B.G.A. TECHNICAL COMMITTEE

TECHNICAL NEWSHEET

TNS 9/10/87

Subject: Preventive measure against aileron flutter.

FIG.1

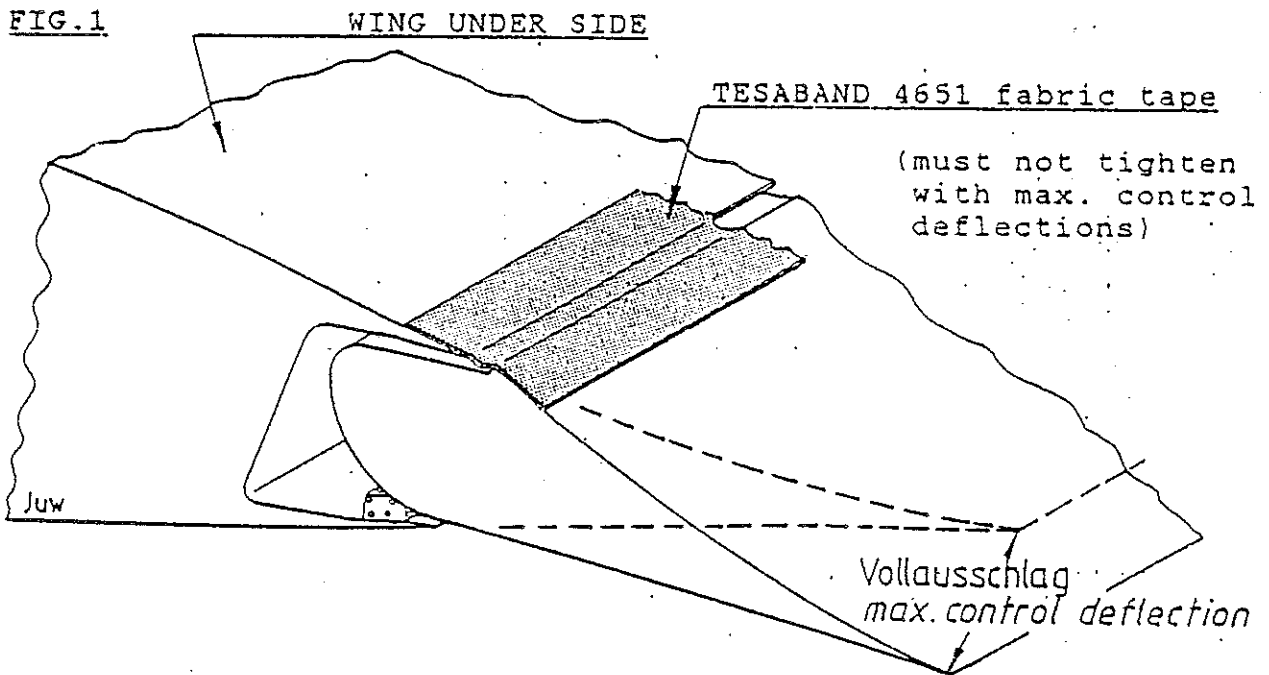
1. Prior to the next take-off it must be checked whether the control surface gap on the wing under side is equipped with a sealing, i.e. either
  - 1.1 with the factory-standard, plastic-treated fabric-tape TESABAND 4651, white, 38 mm wide (see Fig.1); in that case the plastic coat on the fabric must not be damaged, discolored or even weather-worn; the tape must not tighten with full control surfaces deflections.
  - or
  - 1.2 with the pre-curved steel strip (0,07 mm thick) or the pre-curved plastic tape (MYLAR 0,25 mm thick) respectively; in that case check that both require absolutely a Teflon sealing tape underneath for the purpose of sealing the gap and reducing the friction (see Fig. 2).

2.1 In case of the factory-standard fabric-tape TESA 4651, white, 38 mm wide, you have to regard the following in addition: if your glider is an ASW 20 or ASW 20 L you do not have to try to make a recess into the wing for the application of the TESA; just tape it onto the wing surface; according to the aerodynamics experts the relatively thick and wide fabric tape serves possibly also as a turbulator preventing laminar separation bubbles on the control surface under sides. But if your ASW 20 and ASW 20 L had already the fabric tape recessed into the wing contour, then you should apply a turbulator in addition (zig-zag or nap tape) which you have to fix directly in front of the fabric tape.

Fig. 2

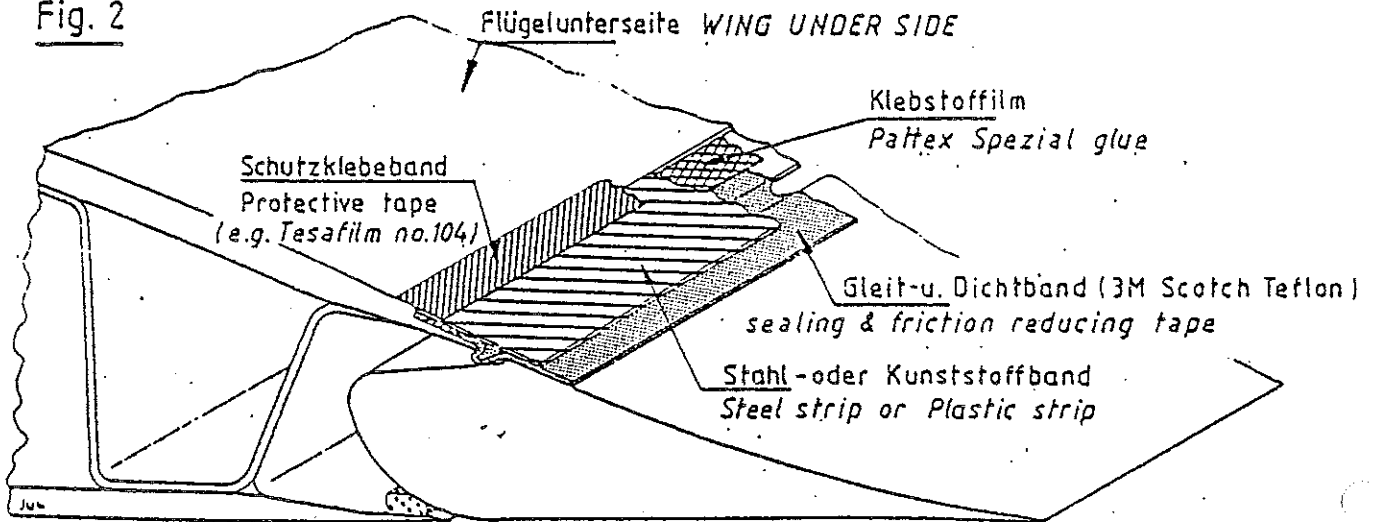
2.2 In case of the elastic lip sealing: this has to be renewed as shown in Fig.2, following the Maintenance Instruction J, Issue III; alternatively, the elastic lip sealing can be new applied instead of the above TESA tape sealing.

SKETCH 1

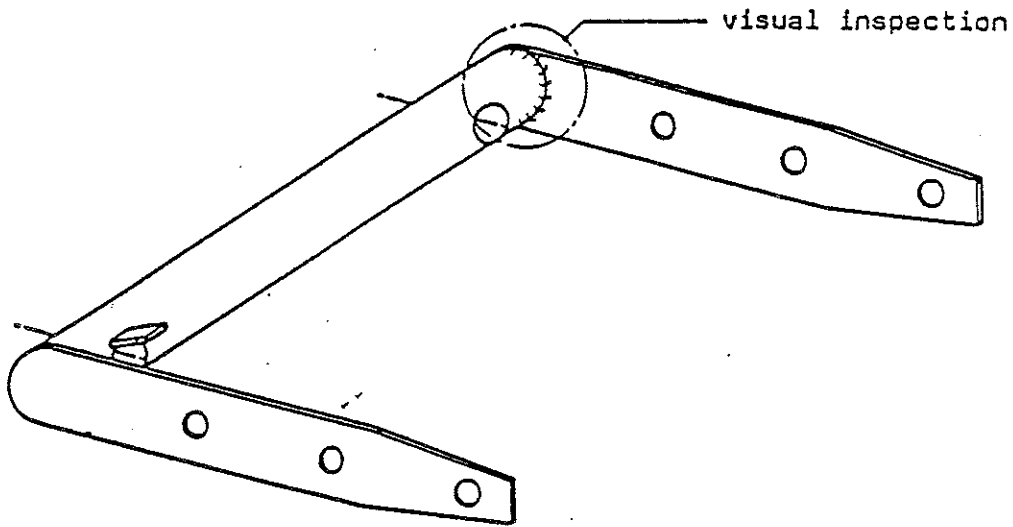
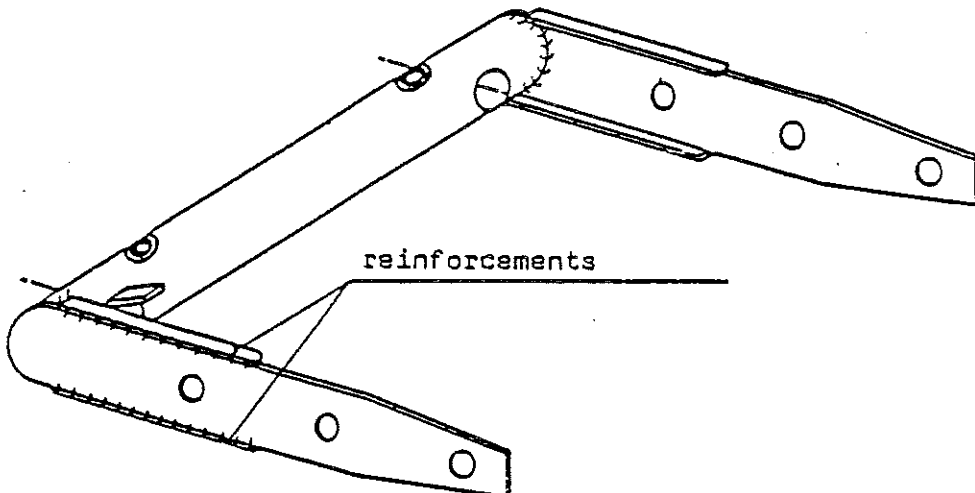
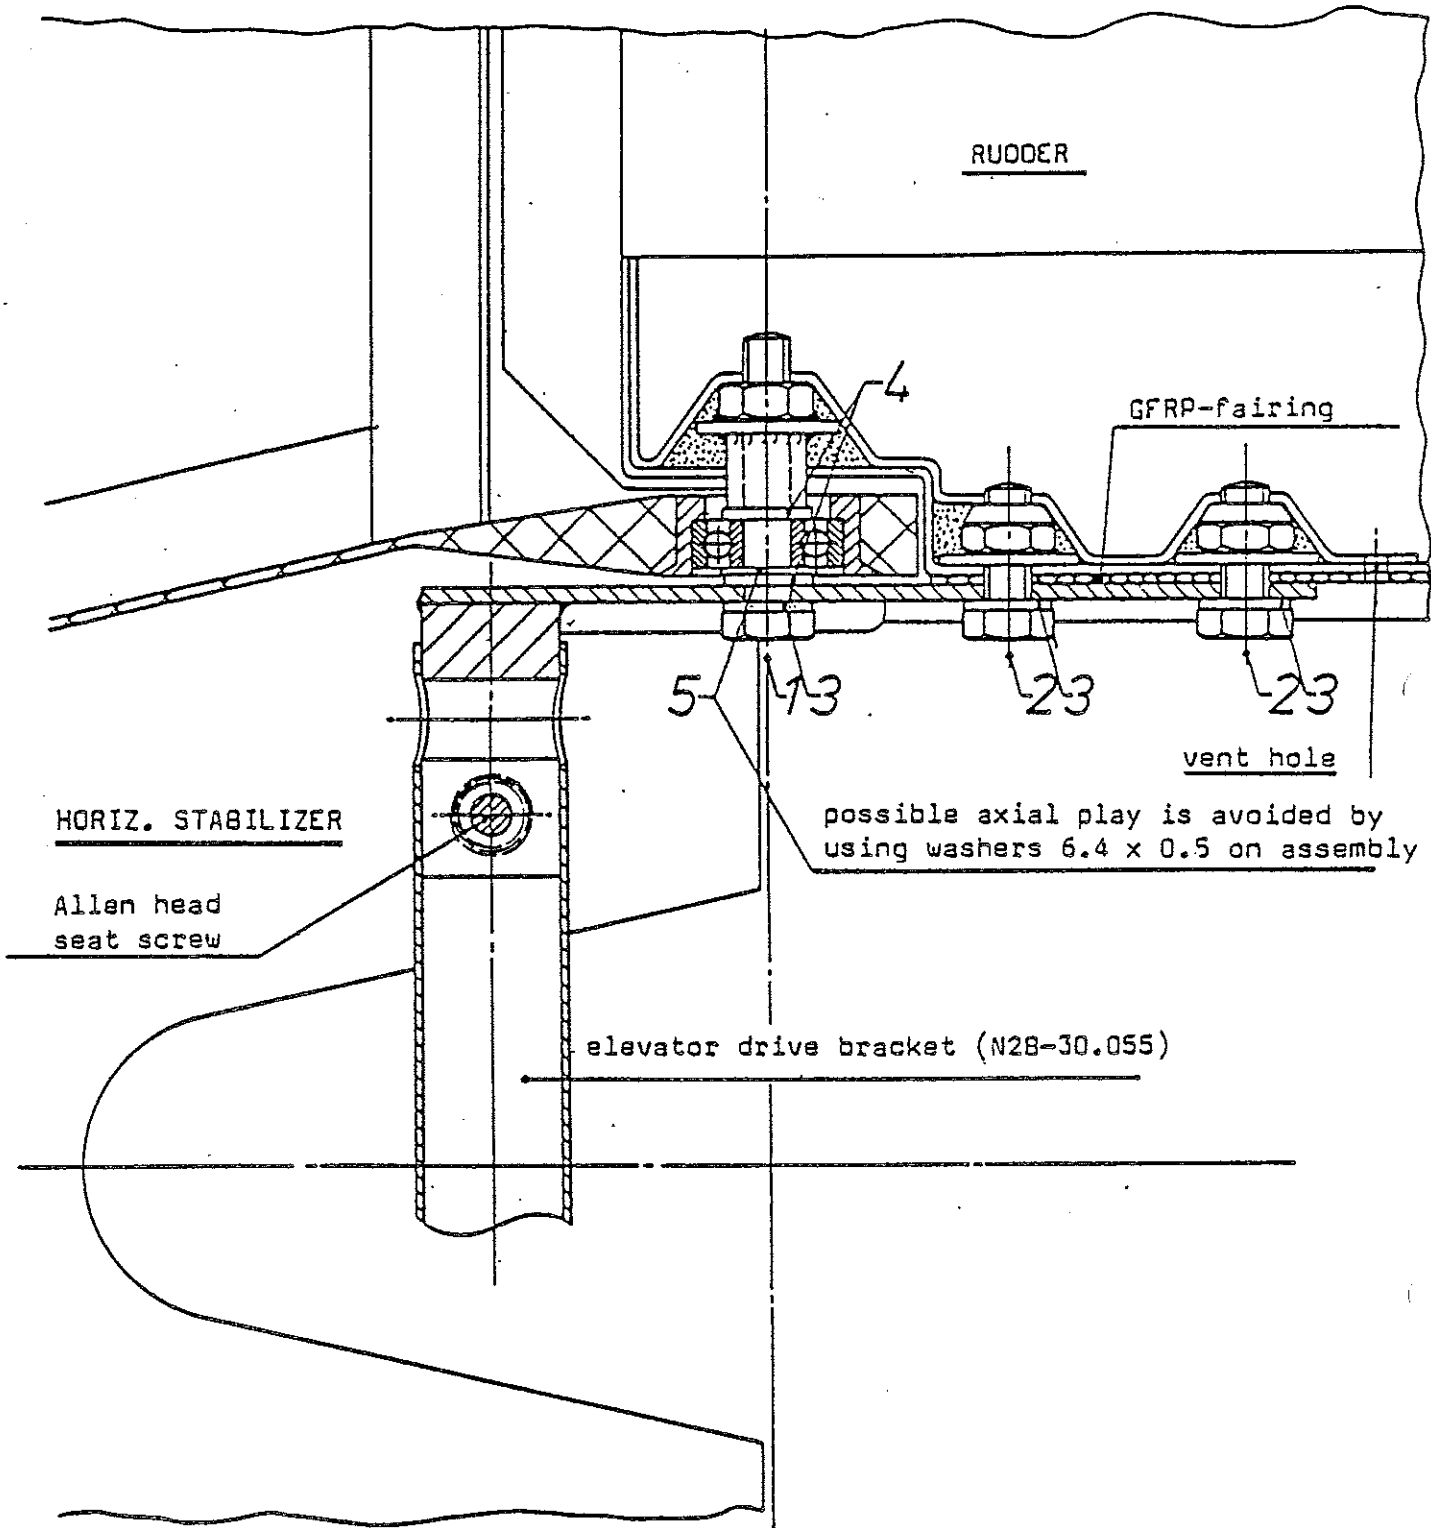
- 1.20 Schempp-Hirth Gliders (Janus B, Nimbus 2B, Mini-Nimbus HS.7. and Mini-Nimbus B). - REINFORCED ELEVATOR BRACKETS (see attached sketch). As a matter of URGENCY (and before November 30th 1987). Manufacturer recomends reinforcement or replacement. T/Notes 328-8 Mini-Nimbus, T/Note 295-19 Janus B, 286-24 Nimbus 2B, Refer - (Sample sketches attached). Details from U.K. Agents.

reinforced elevator drive bracket

Abb. 1  
fig. 1

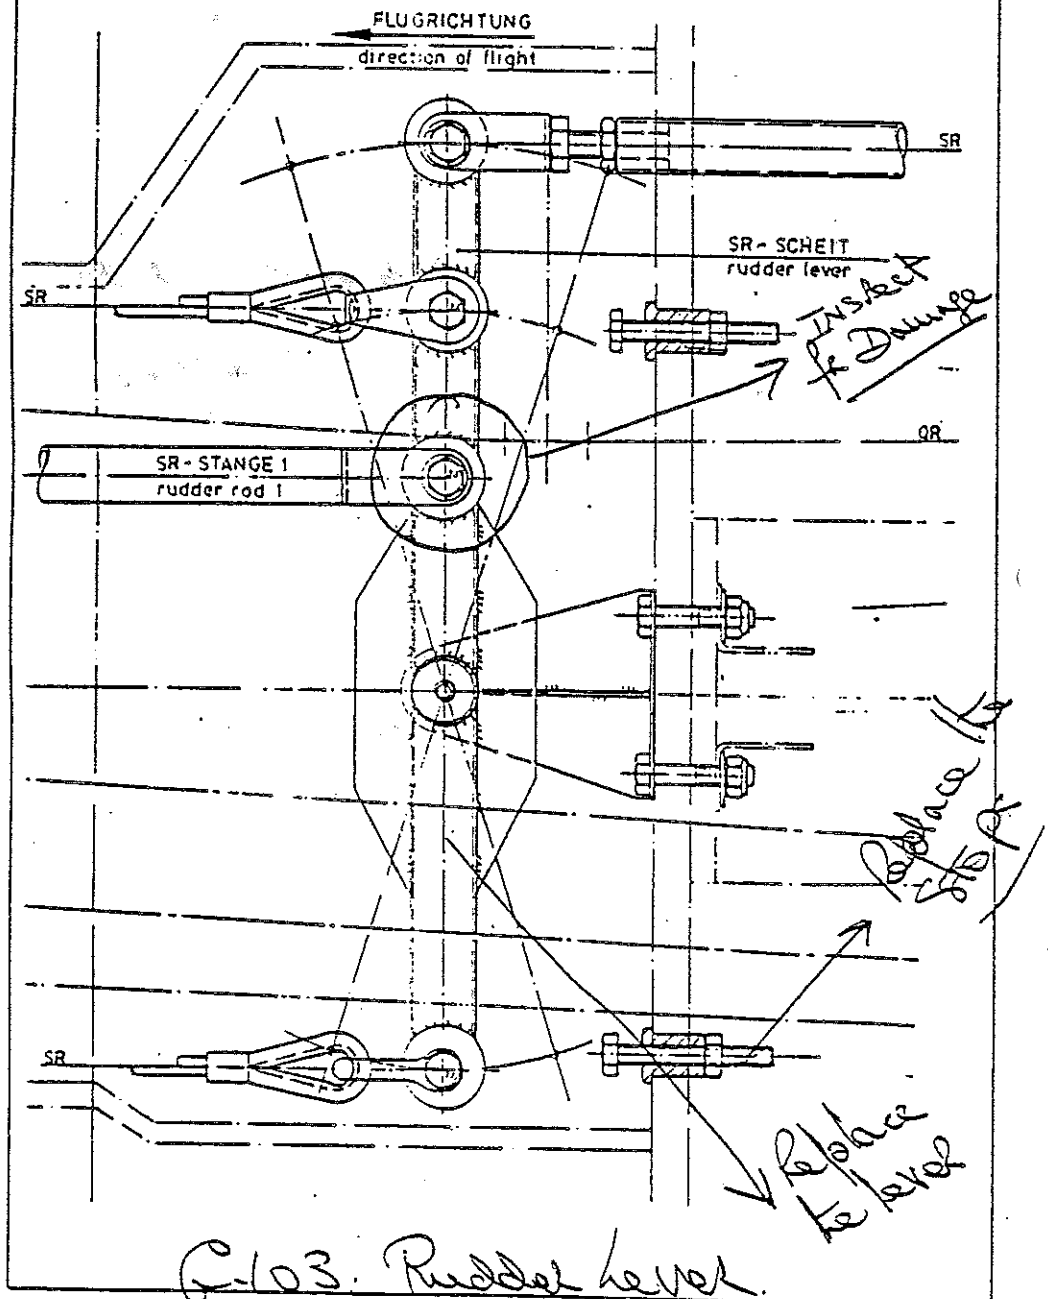
- Instructions:**
1. Instruction: Checking the rudder lever for signs of predamage.
    - 1.1 Visually inspect the complete rudder lever prior to next take-off for signs of predamage. Checking the lever requires implementation of the Repair Instruction No. 315-33/1 which is a component of the present Service Bulletin.
    - 1.2 When no damage to the lever is discernible there is no need to repeat Instruction 1 until the rudder lever is replaced according to Instruction 2.
    - 1.3 Should predamage be evident, Instruction 2 must be implemented before next take-off.
  2. Instruction: Replacing the rudder lever
    - 2.1 Changing the rudder lever and the stops shall be implemented in accordance with Repair instruction No. 315-33/2 not later than 31.01.1988.

K6CR PUSH ROD FOLLOWING BELL CRANK.

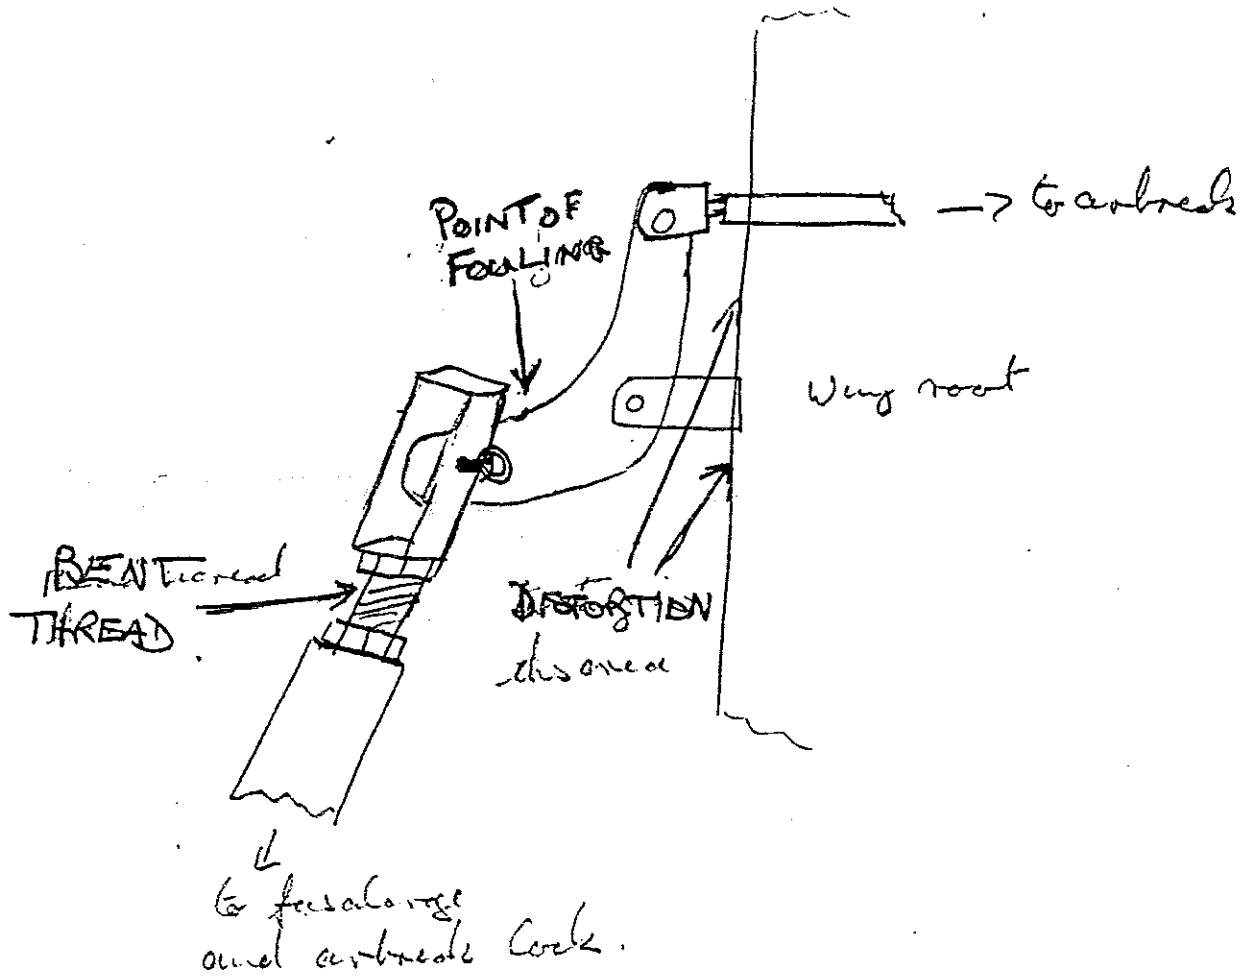
- 1.5. Bocians - cable systems too tight Aileron cable tensions were found to be excessive, and likely to cause damage. (Reported by Highland G.C.).
- 1.6. Ka6GR Airbrake push-rod bent and excessive load applied to bellcrank at root end. (Reported by Highland G.C. & sketch attached).
